Ref No.: YEU-MB107 Date: February 6, 2013

To : All YEU Marine Distributors in Europe, CIS & Africa Subject : Introduction of new Yanmar Sail drive SD60

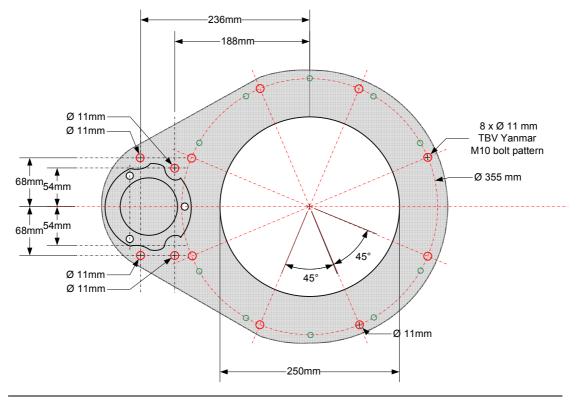
The new SD60 is compatible with the previous SD50. Please find below the items that need to be considered during installation :

A) Engine bed

• The shape of the engine bed is almost similar to that off the SD50 Sail Drive, with a difference in the space required for the rear engine mount. During installation it is necessary to check whether or not the existing engine bed has enough material to support the SD60 Sail Drive, as the rear flexible mount must be fully supported by the engine bed. [See below installation drawing]

The drive is fixed to the engine bed by 8 x M10 bolt + 4 x M10 bolt. (or studs with nuts).

• If there is not enough FRP material to give the SD60 Sail Drive enough support, one must either modify the engine bed or alternatively use a an adaptor plate to ensure enough support. This adapter plate will be made available by Yanmar Europe as an option, also for replacement of SD50 Sail Drive to SD60 Sail Drive.
